APPLICATION FOR SOIL INVESTIGATION

APPENDIX H
SITE EVALUATION

SITE INVESTIGATION REPORT
INDIVIDUAL SEPTIC TANK SYSTEM
WITH SUBSURFACE,
SOIL ABSORPTION,
EFFLUENT DISCHARGE

LOCATION OF LOT Beatties Ford Road and Neck Road

* See Diagram on Back (Include: Soil areas, property lines, roads, streams, gullies, wet areas, fill areas, wells, water bodies, slope patterns, etc)

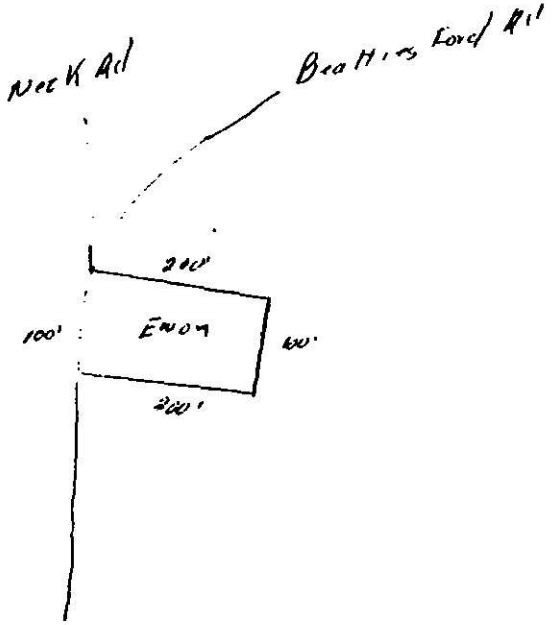
FACTORS	AREA 1	AREA 2	AREA 3	AREA 4
1. SLOPE (%)	(S) PS 2-6% U	S PS U	S PS U	S PS U +
2. SOIL TEXTURE (12-36 in.) (Sandy, loamy, clayey, Note 2:1, Clay)	S PS 2-1 clay (U)	S PS U	S PS U	S PS U
3. SOIL STRUCTURE (12.36 in.) (Clayey Soils)	S PS Weak Blocky (U)	S PS U	S PS U	S PS U
4. SOIL DEPTH (In.)	S PS <40" (U)	S PS U	S PS U	S PS U
5. RESTRICTIVE HORIZONS (In.) (Imprevious Strata, Rock)	(S) PS None U	S PS U	S PS U	S PS U
6. SOIL DRAINAGE/GROUNDWATER (External & Internal)	(S) PS >6' to ground water U	S PS U	S PS U	S PS U
7. SOIL PERMEABILITY (Percolation Rate)	S PS V. slow (U)	S PS U	S PS U	S PS U
8. OTHER (Specify)	S PS U	S PS U	S PS U	S PS U
9. SITE CLASSIFICATION	unsuitable			
SOIL SERIES	Enon

Soil Structure Weak Blocky

Soil Permeability Unsuitable

Sites classified as Unsuitable are not acceptable for soil absorption of sewage effluent However, if engineering, geologic, soil, and environmental studies indicate that a suitable septic tank system or a suitable alternate system can be expected to function satisfactorily, such sites may be re-classified as Provisionally Suitable. (Section 10 of the North Carolina Administrative Code 10 A,.1910)

If you desire to file for permission to install an "alternate or modified" system, you should present this office with your proposals in the form of plans and specifications. These would be reviewed and if it is found that the system may reasonably be expected to function satisfactorily, approval may be given on the execution by you of a "Septic Tank Agreement Form" available in this office.
